CASE NO: MJS14-01/ Mon County Habitat for Humanity / Deckers Court
PRELIMINARY PLAT

PLANNING AND ZONING CODE CONFORMITY REPORT
STAFF REPORT SUPPLEMENT
PLANNING DIVISION

MJS14-01/ Mon County Habitat for Humanity / Deckers Court
PRELIMINARY PLAT

HFH Entrance.pdf
197 KB

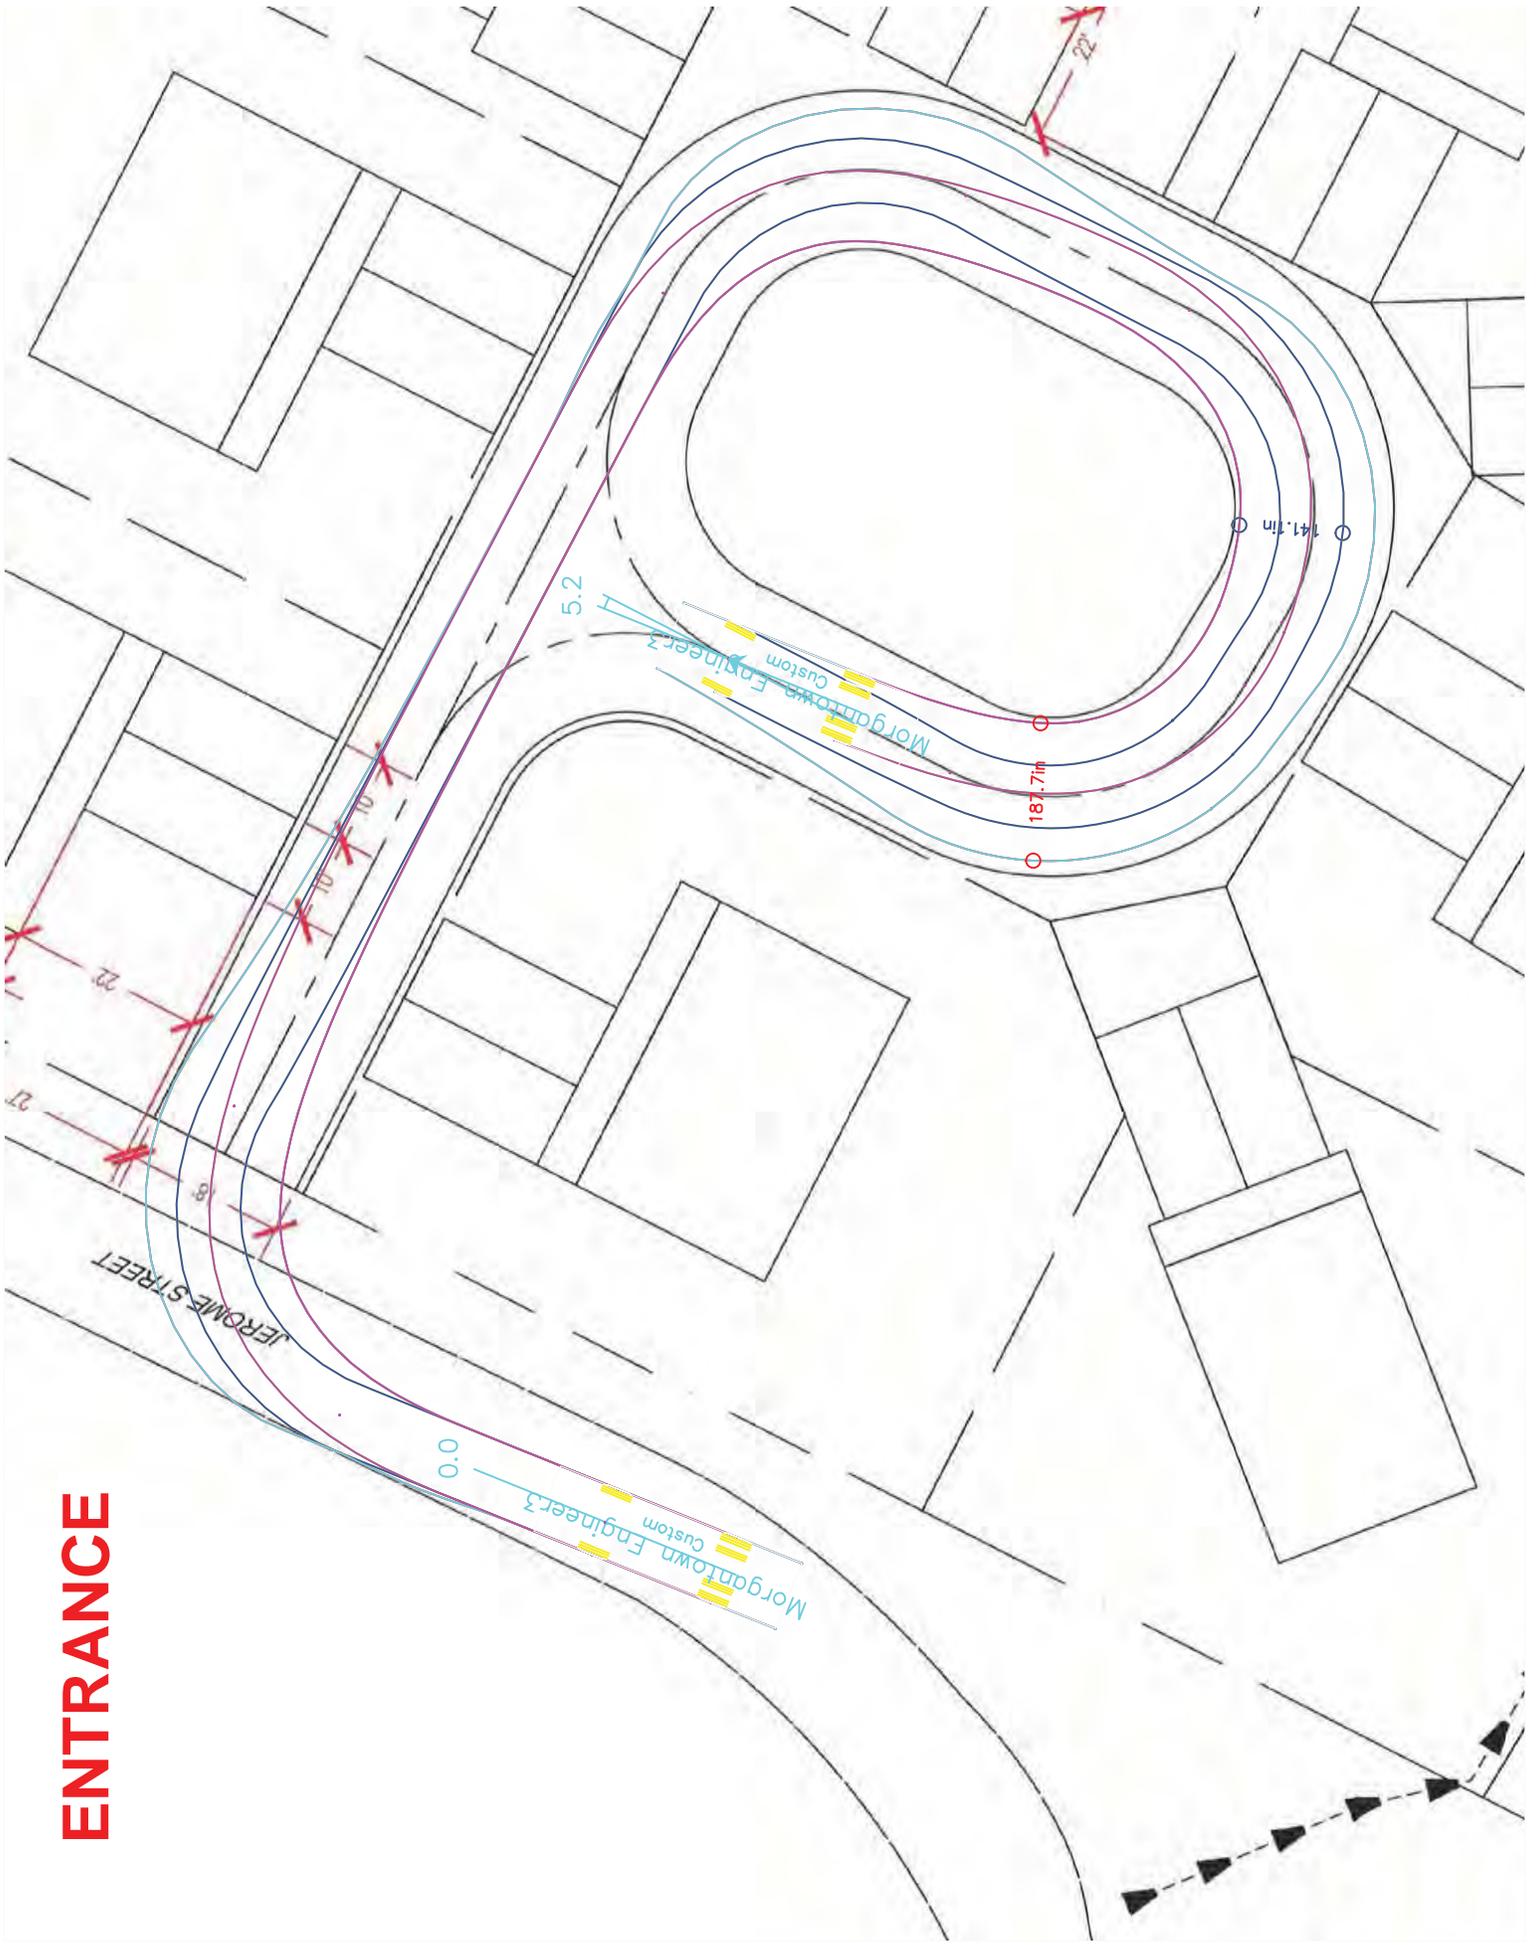
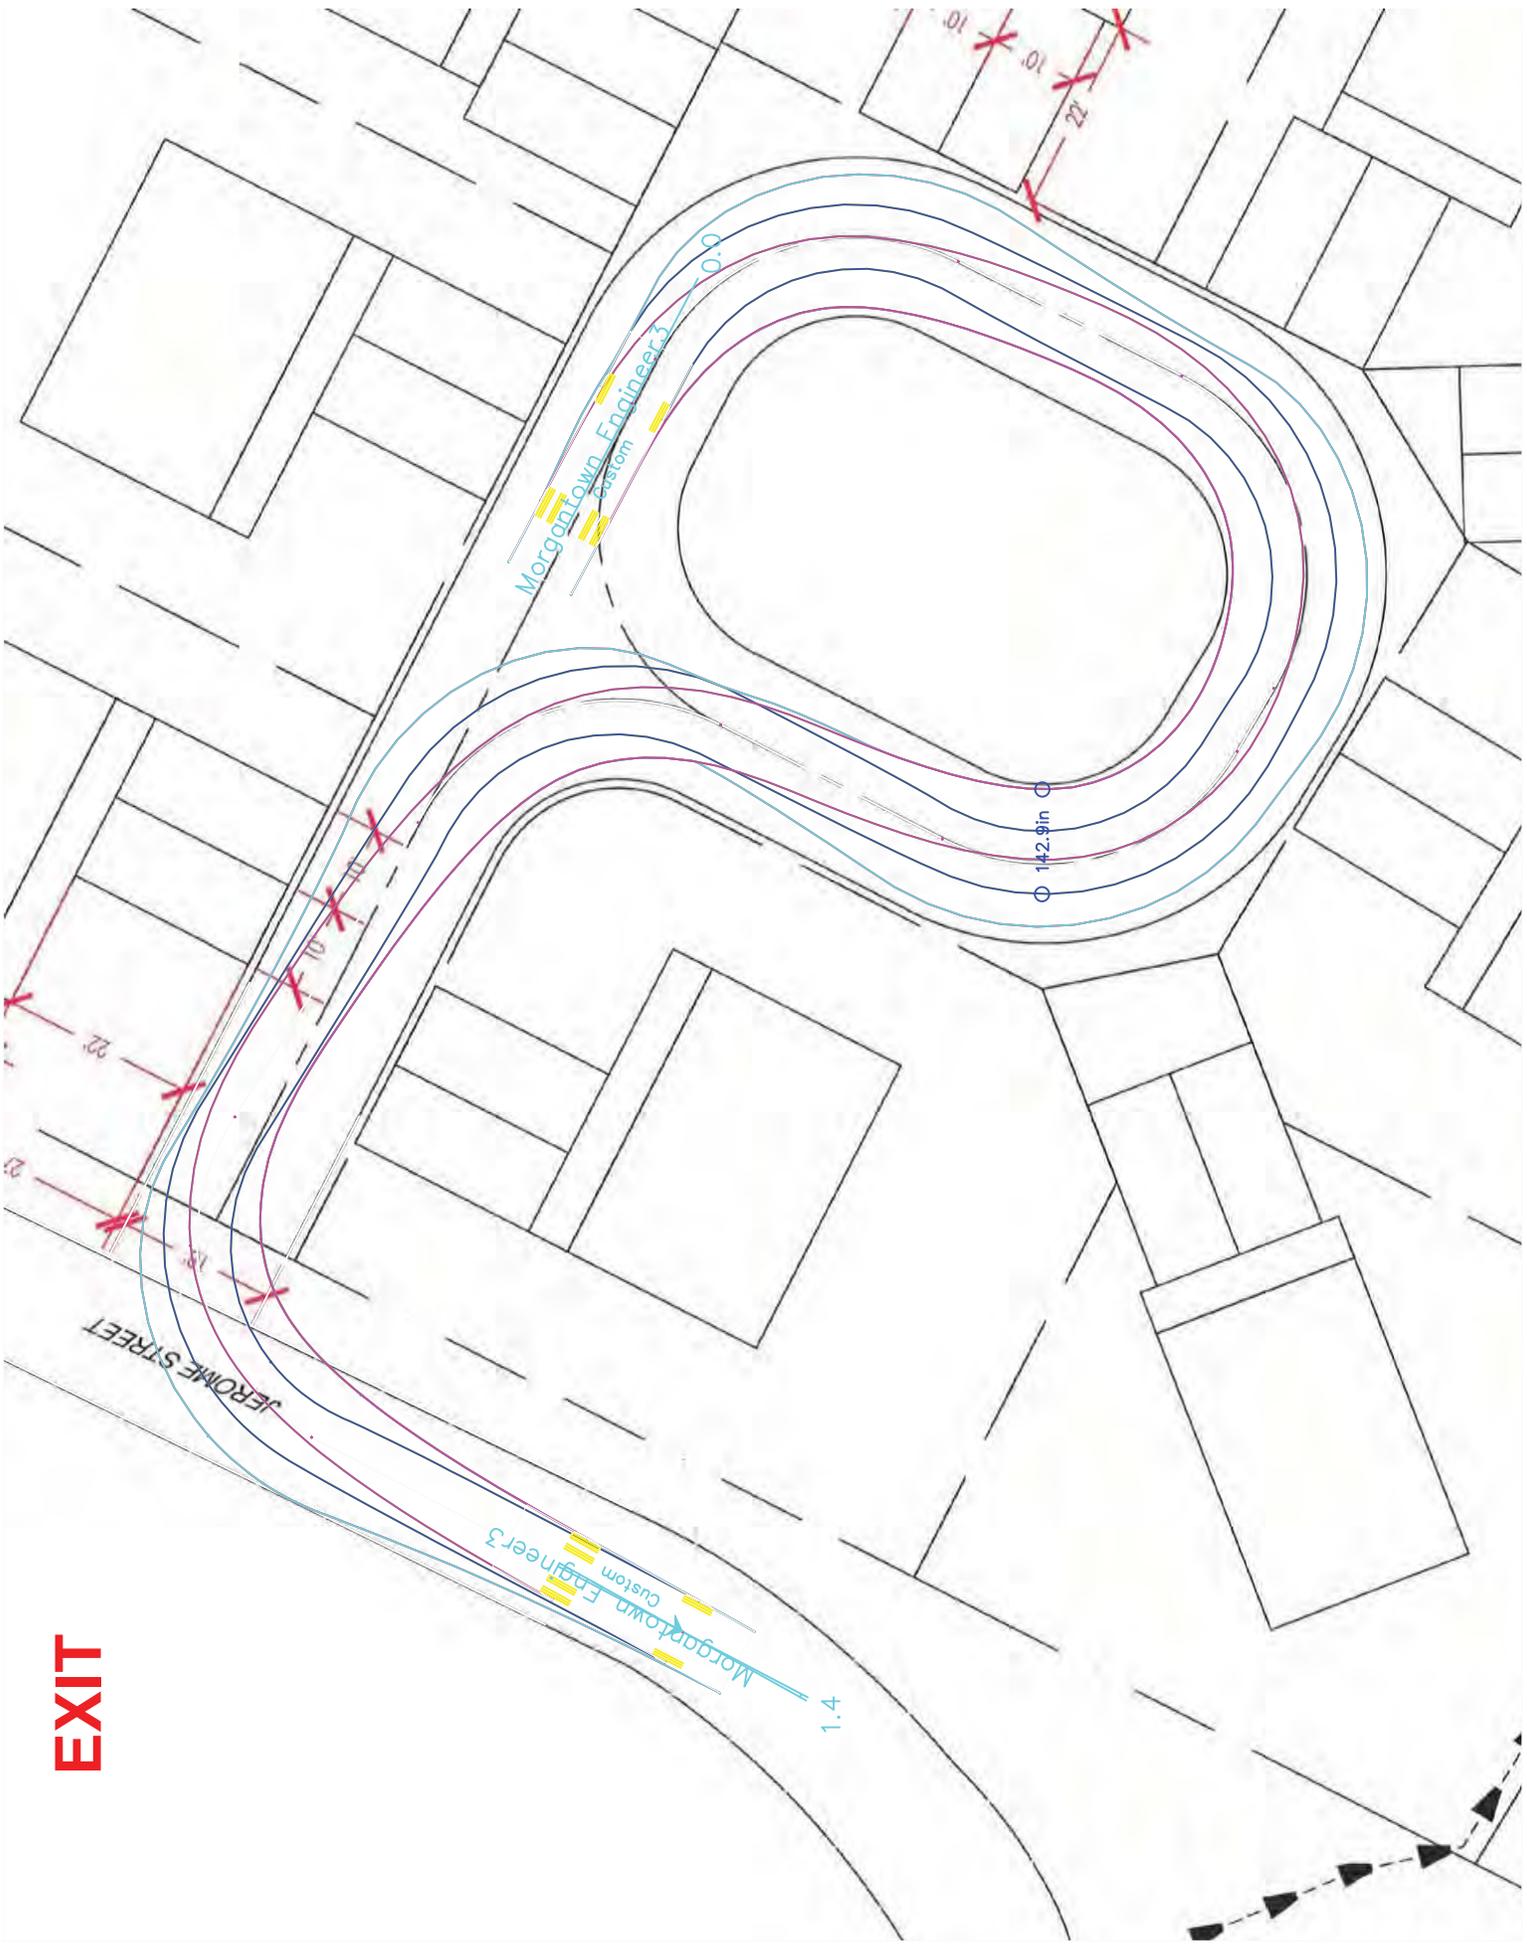
I have run the AutoTurn simulation of Morgantown's Engine 3 fire truck on the site plan you provided me. The fire truck can maneuver through the site but cuts the corner while entering and exiting the site. This can be fixed by modifying the entrance design. If you have any questions please feel free to call.

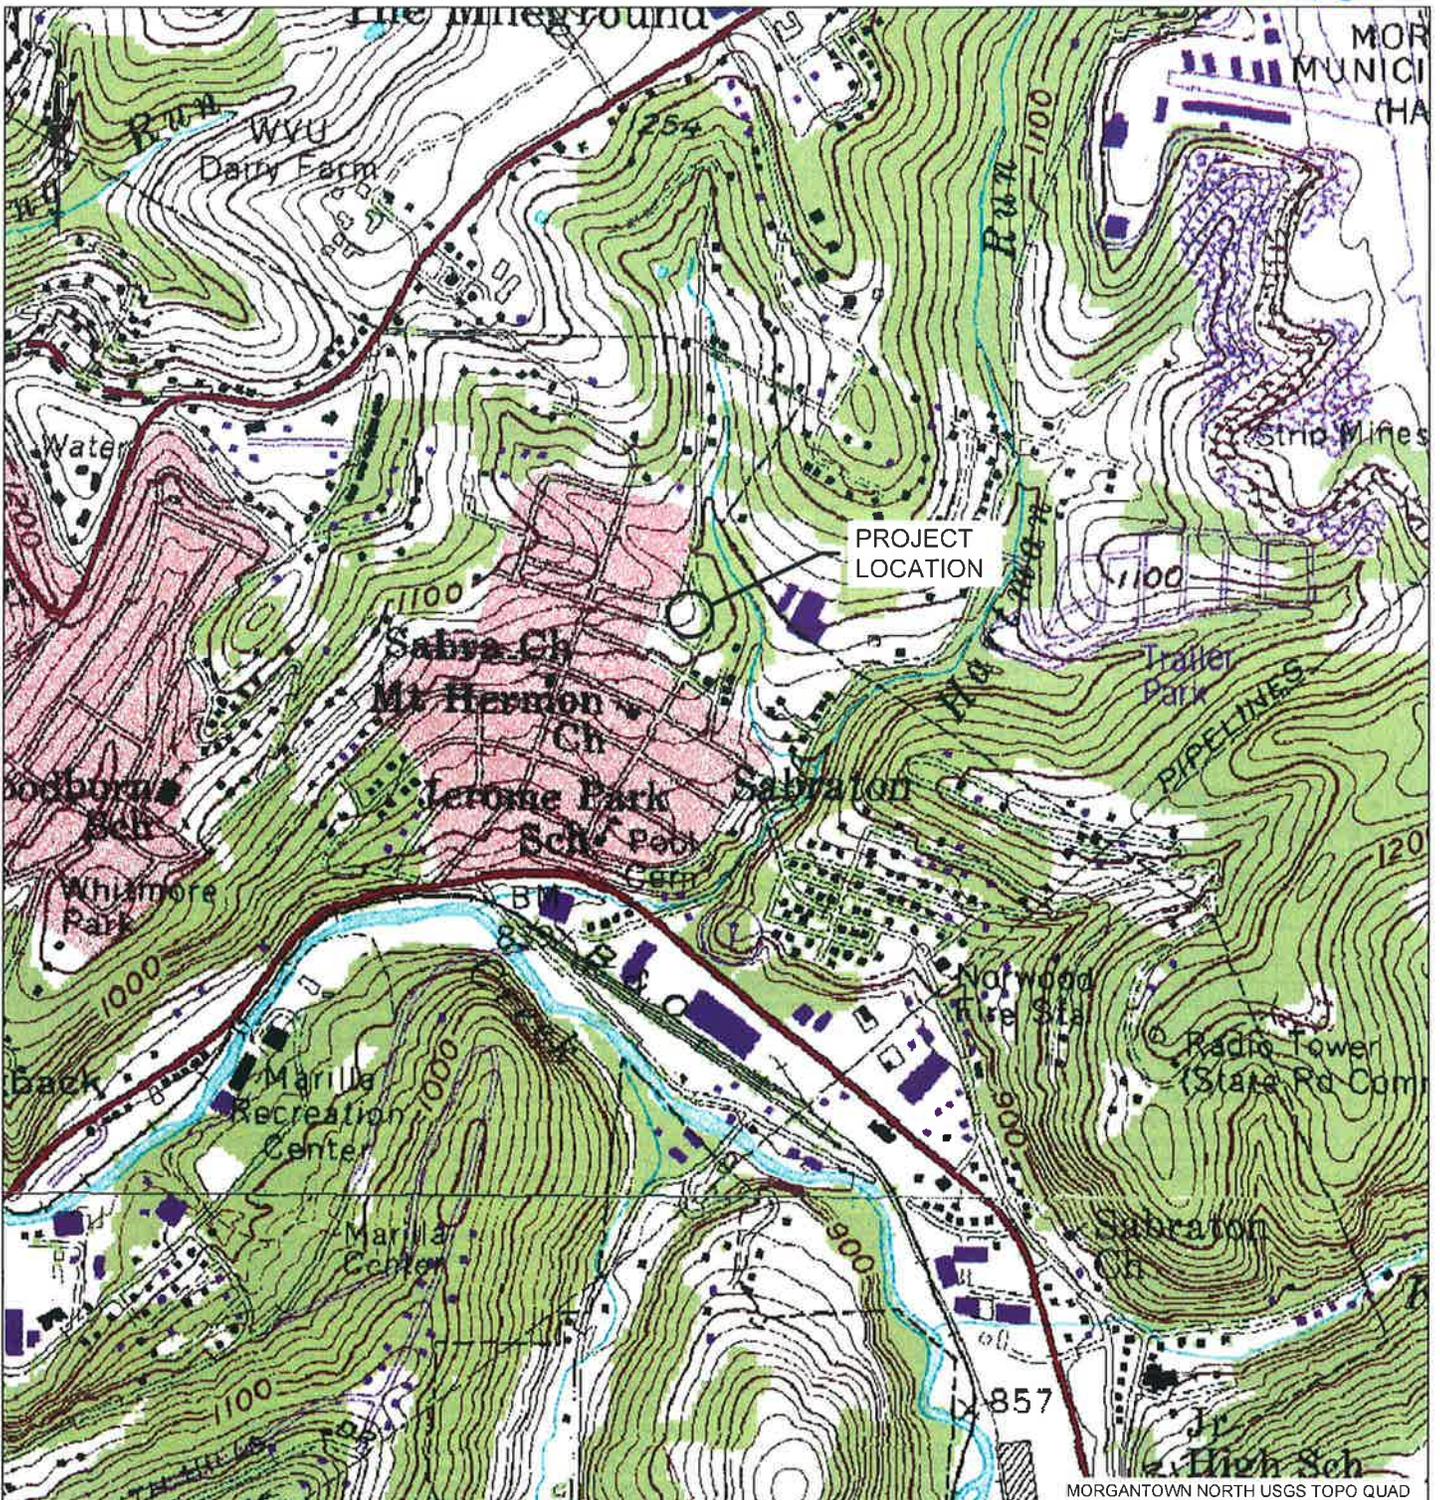
N	(g) The corners of lots at street intersections, shall have a curve with a minimum radius of twenty feet joining the two sidelines of such rights-of-way.
	Lots labeled 1 and 10 do not provide the minimum radius at the intersection of the Jerome Street and the proposed cul-de-sac. Staff recommends that the requisite minimum radius be provided in the final plat documents.

Code Citation	Requirement
1321.02 (a)(1)	Every subdivision shall have access to a public right-of-way.
	The lot labeled “SWM AREA” does not have access to a public right-of-way
1321.02 (c)(6)	Each cul-de-sac shall be provided with a turnaround having a minimum right-of-way radius of fifty feet
	The proposed right-of-way width for the turnaround is forty (40) feet.
1321.06 (f)	No corner lot shall have a width at the building line of less than seventy-five feet.
	The widths of the building lines, relative to “Lot Front,” of the Lots labeled 1 and 10 are 46.25 feet and 59.00 feet respectively.

Code Citation	Requirement										
1321.06 (g)	The corners of lots at street intersections, shall have a curve with a minimum radius of twenty feet joining the two sidelines of such rights of way. <hr style="border-top: 1px dashed black;"/> <td style="text-align: center;">1323.03 (d)</td> <td><table style="width: 100%; border-collapse: collapse;"><thead><tr><th style="text-align: center; border-bottom: 1px solid black;"><u>Type of Street</u></th><th style="text-align: center; border-bottom: 1px solid black;"><u>Right-of-way</u></th><th style="text-align: center; border-bottom: 1px solid black;"><u>Width of Pavement</u></th></tr></thead><tbody><tr><td style="text-align: center;">Cul-de-sac</td><td style="text-align: center;">40 feet</td><td style="text-align: center;">20 feet</td></tr></tbody></table><hr style="border-top: 1px dashed black;"/><td style="text-align: center;">1323.03 (d)</td><td>The proposed right-of-way width of the cul-de-sac appears to be 20 feet and the proposed width of the pavement is 18 feet.</td></td>	1323.03 (d)	<table style="width: 100%; border-collapse: collapse;"><thead><tr><th style="text-align: center; border-bottom: 1px solid black;"><u>Type of Street</u></th><th style="text-align: center; border-bottom: 1px solid black;"><u>Right-of-way</u></th><th style="text-align: center; border-bottom: 1px solid black;"><u>Width of Pavement</u></th></tr></thead><tbody><tr><td style="text-align: center;">Cul-de-sac</td><td style="text-align: center;">40 feet</td><td style="text-align: center;">20 feet</td></tr></tbody></table> <hr style="border-top: 1px dashed black;"/> <td style="text-align: center;">1323.03 (d)</td> <td>The proposed right-of-way width of the cul-de-sac appears to be 20 feet and the proposed width of the pavement is 18 feet.</td>	<u>Type of Street</u>	<u>Right-of-way</u>	<u>Width of Pavement</u>	Cul-de-sac	40 feet	20 feet	1323.03 (d)	The proposed right-of-way width of the cul-de-sac appears to be 20 feet and the proposed width of the pavement is 18 feet.

- The final plat should include property boundary adjustments OR a “Reserve Strip”, as defined in Article 1313.01(26) in the P&Z Code, via an access easement to ensure access to the Lot labeled “SWM AREA.” The recommended minimum width of the means of access from the proposed cul-de-sac right-of-way to the Lot labeled “SWM AREA” is fifteen (15) feet.
- The corners of Lots labeled 1 and 10, which are located at the proposed Jerome Street and cul-de-sac intersection, be modified to include a curve with a minimum radius of twenty (20) feet joining the sidelines of such rights-of-way.

Additionally, Staff recommend that the Planning Commission grant variance relief from Articles Article 1321.02(c)(6) and Article 1323.03 (d); provided concurrence is obtained from the City Fire Marshal.
